# Access Compliance Report

## Public Rights-of-Way

Intersection ID: 21378	Main Street: CAMBRIDGE BELTWAY DR	Cross Street: LENOX POINTE DR	Location: S
ADA ID: 6718456829CB	Ramp Type: PerpDiag	Initial Pass/Fail: Fail	Overall Compliance: No
Codes/Mitigation Info/Possible Solution		Field Measurements/Component Compliance	
Severity Score: 13.75

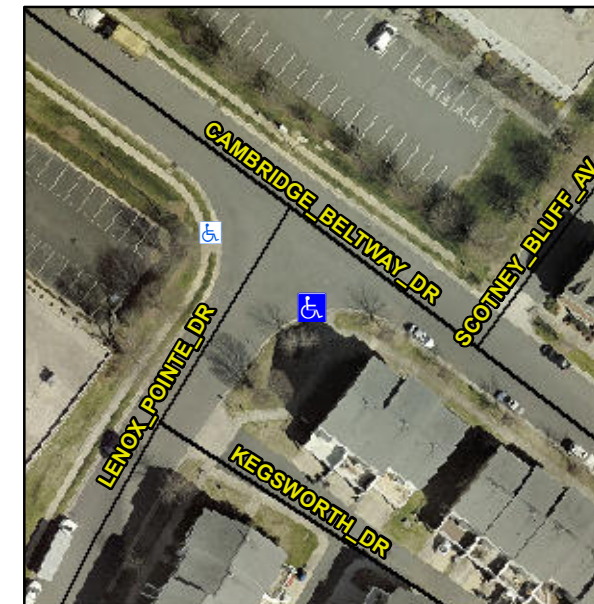
**R304.2.2, R304.5.3**

Compliance	Description	Data	Compliance	Description	Data
N/A	Ramp Length (in)	98.0	No	Ramp Slope (%)	8.9
Yes	Ramp Width (in)	51.0	No	Ramp XSlope (%)	4.1
N/A	Flare Type LT	N/A	N/A	Flare Type RT	N/A
N/A	Flare Slope LT (%)	N/A	N/A	Flare Slope RT (%)	N/A
N/A	Flare Traversable LT?	N/A	N/A	Flare Traversable RT?	N/A
N/A	Landing Length (in)	N/A	N/A	DWS Provided?	N/A
N/A	Landing Width (in)	N/A	N/A	DWS Contrast?	N/A
N/A	Landing Slope (%)	N/A	N/A	DWS Length (in)	N/A
N/A	Landing X Slope (%)	N/A	N/A	DWS Full Width?	N/A
N/A	Landing Curb? (Y/N)	N/A	N/A	DWS Offset (in)	N/A
N/A	Shared Landing?	N/A			
N/A	Gutter Ponding?	N/A	N/A	Gutter Slope (%)	N/A
N/A	Gutter Lip Ht (in)	N/A	N/A	Gutter X Slope (%)	N/A
N/A	Painted X Walk1?	No	N/A	Painted X Walk2?	No
	X Walk 1 Direction	To NE		X Walk 2 Direction	To NW
N/A	X Walk 1 Width (in)	N/A	N/A	X Walk 2 Width (in)	N/A
	X Walk 1 Slope (%)	1.0		X Walk 2 Slope (%)	0.8
	X Walk 1 X Slope (%)	1.6		X Walk 2 X Slope (%)	0.7

**Remove & Replace Curb Ramp With Two New Directional Ramps or Equivalent.**
